ADDENDUM NO. 3 TO PROJECT NO. 43262

**PROVIDE LONG TERM CARE ADDITION AT G-WING
RENOVATE C AND E WINGS WALSH MEDICAL RMU
WALSH MEDICAL RMU
BUILDING NO. 52
MOHAWK CORRECTIONAL FACILITY
6514 STATE RTE. 26, ROME N.Y.**

October 7, 2011

DRAWING NUMBER: A-107

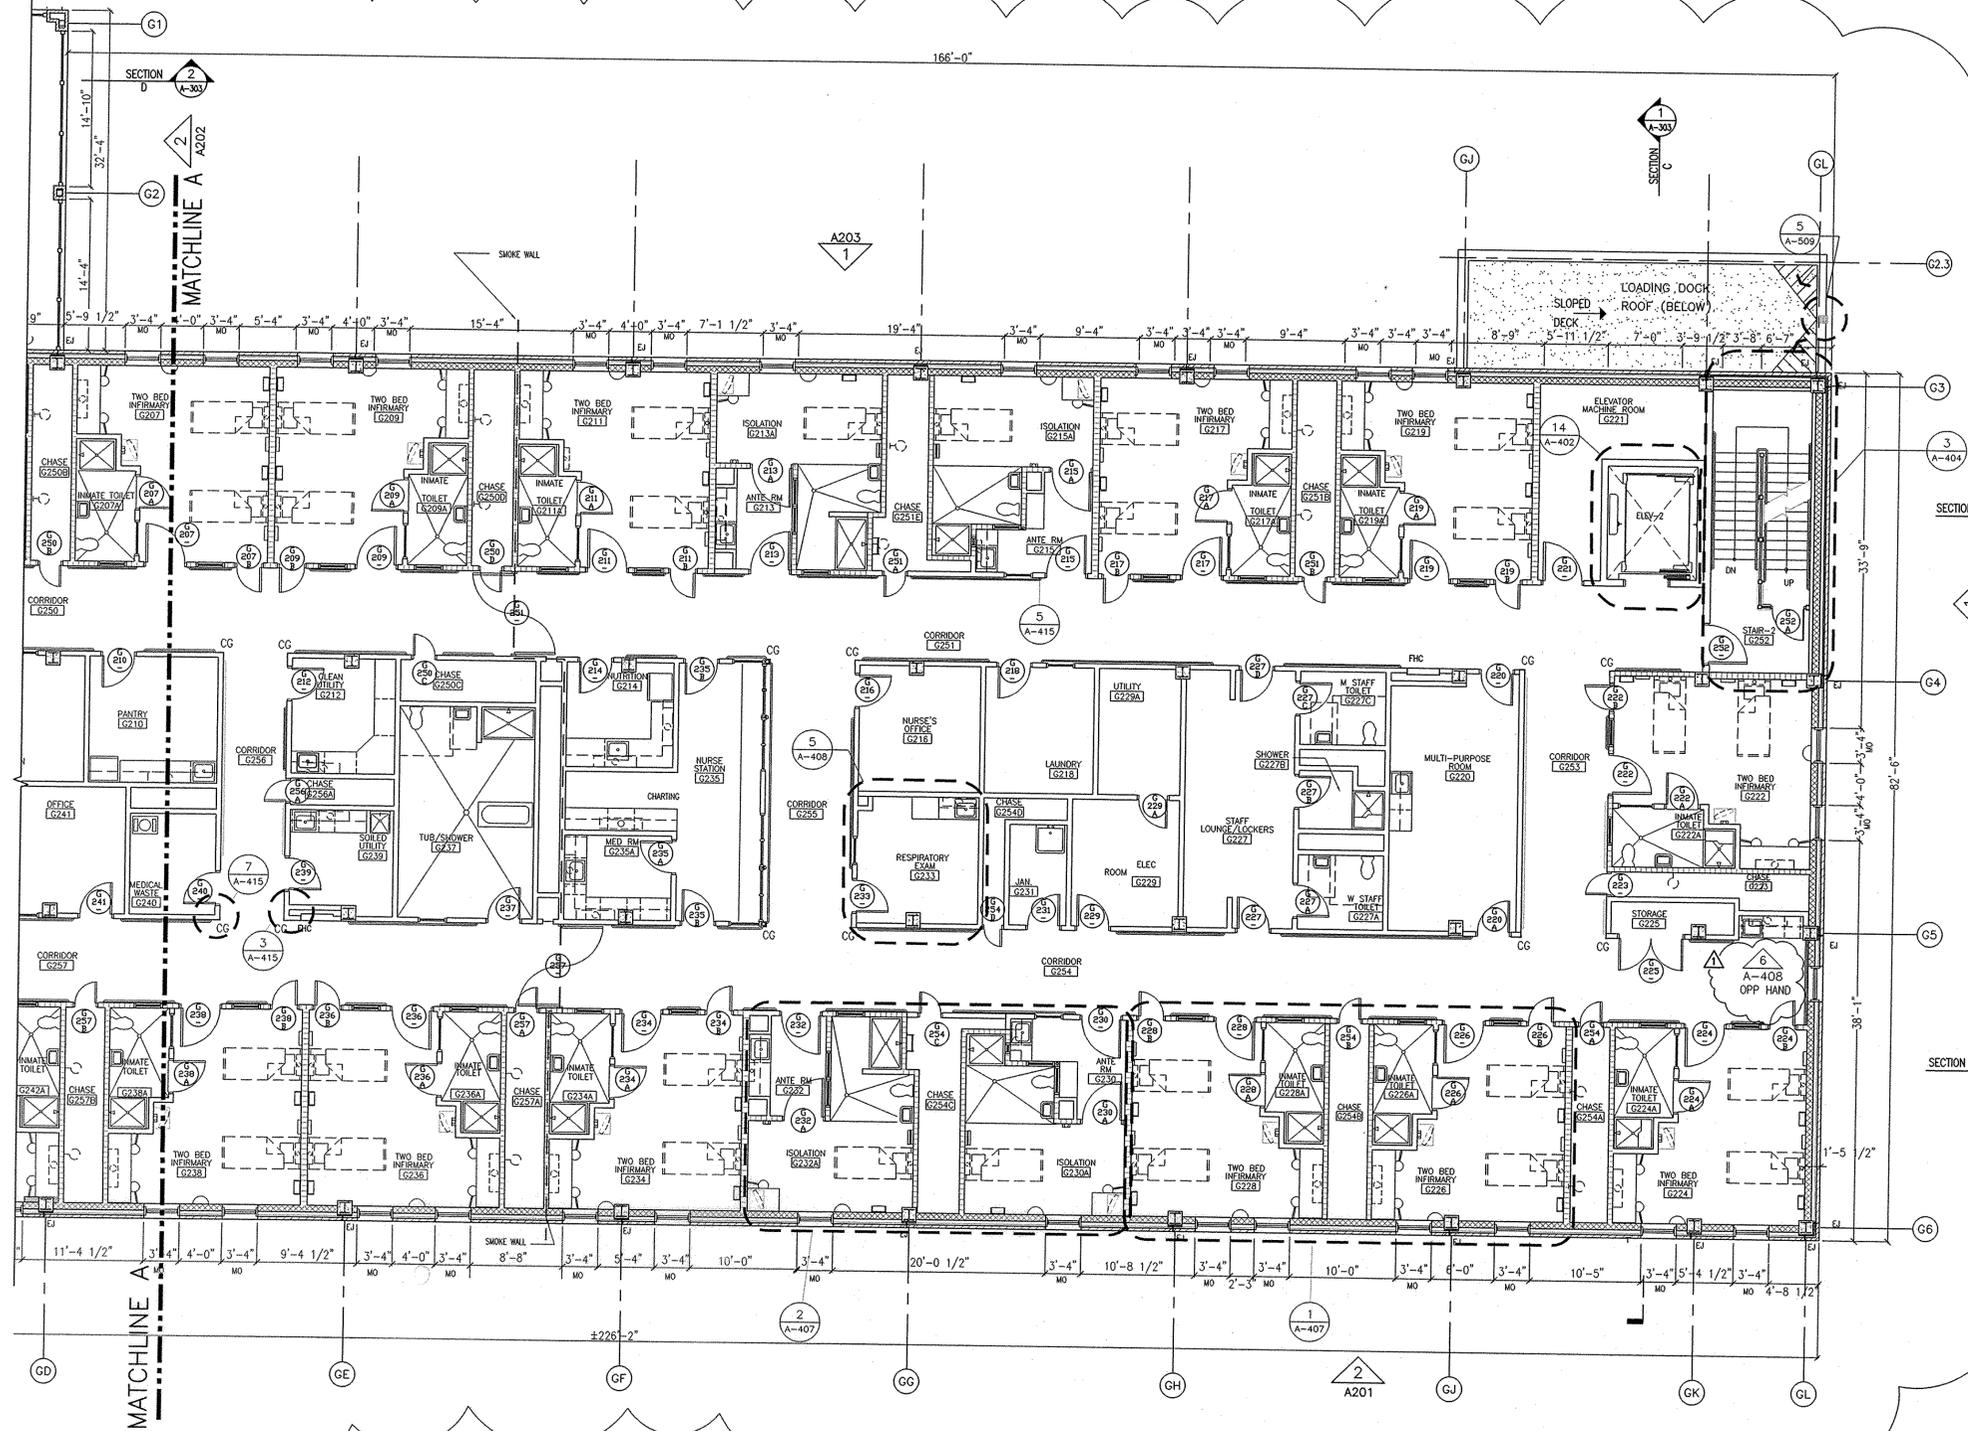
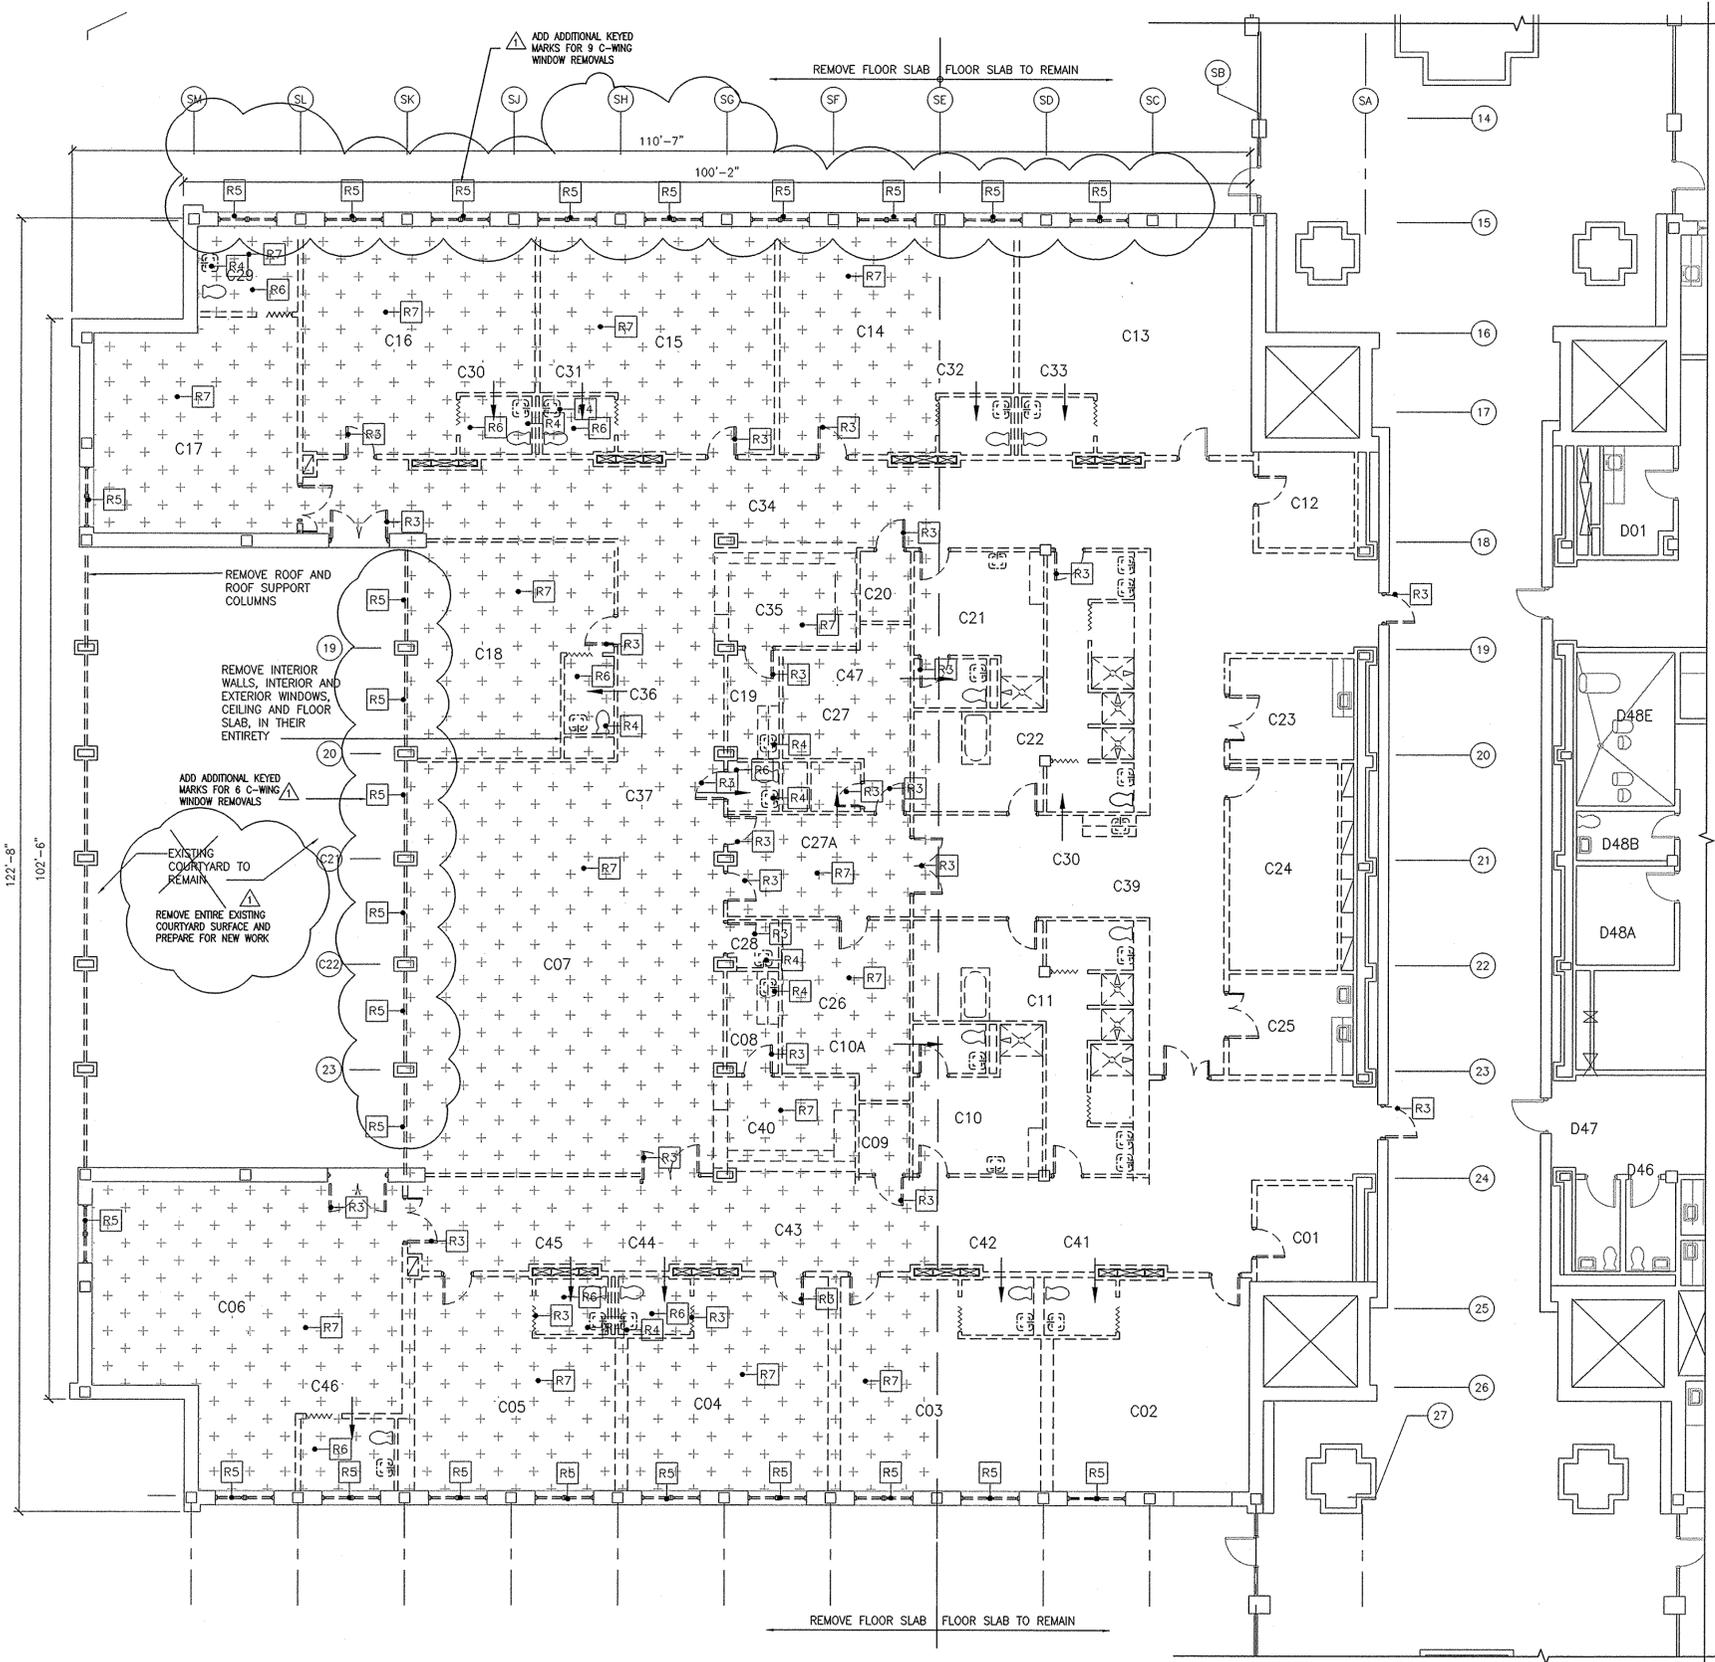
ADD WINDOW TYPE IDENTIFICATION SYMBOLS

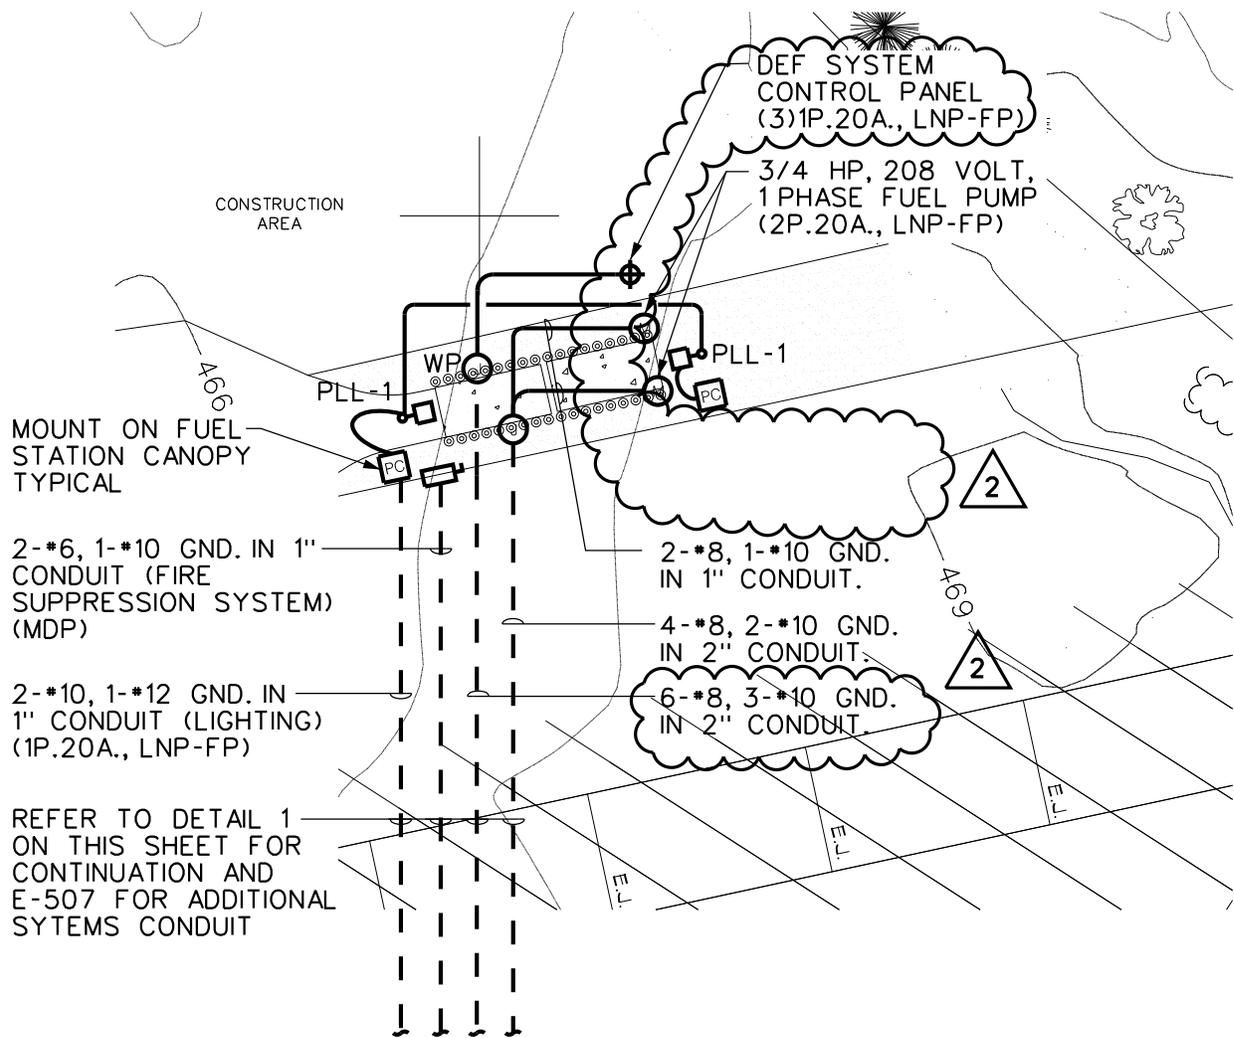
35. DRAWING E-120 - SITE PLAN - ELECTRICAL: Revise diesel exhaust fluid connections. See attached Sketches E-706 and E-707.

REFERENCE DRAWING: E-610

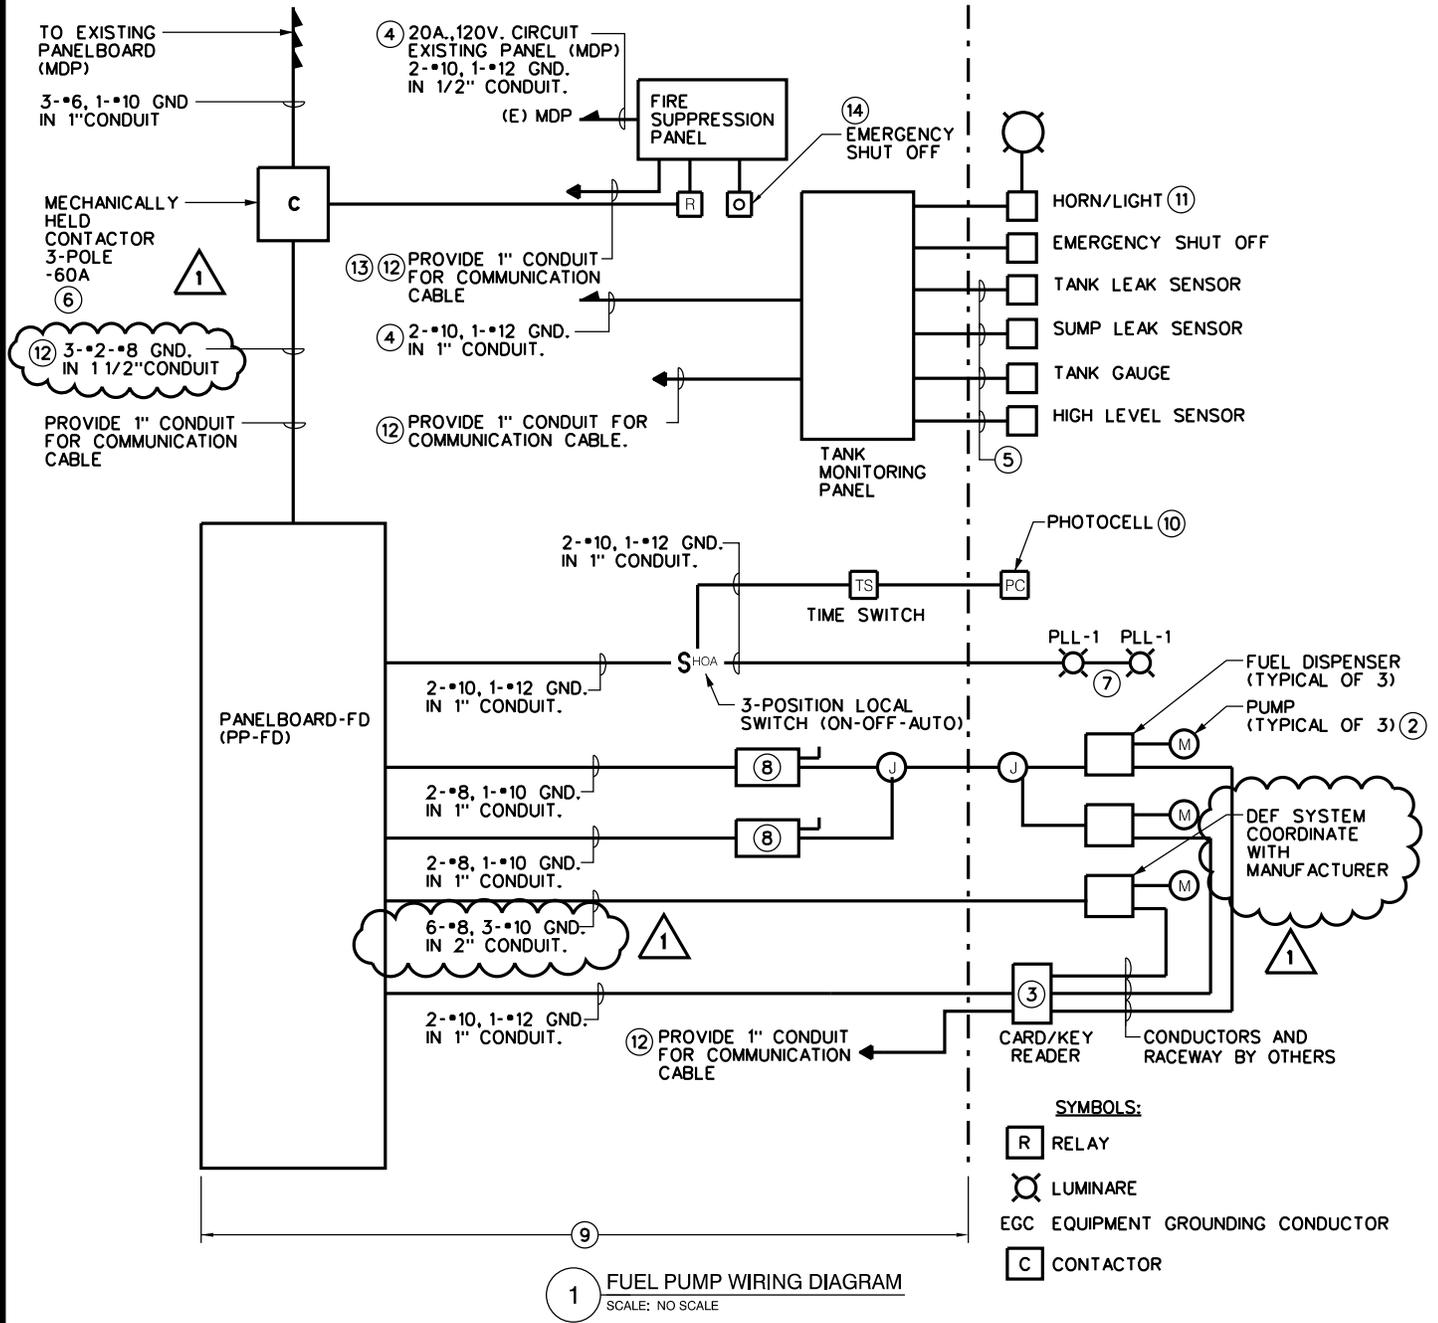
38. DRAWING E-610 - PANEL SCHEDULES: Revise Panelboard LNP-FP. See attached Sketch E-708.
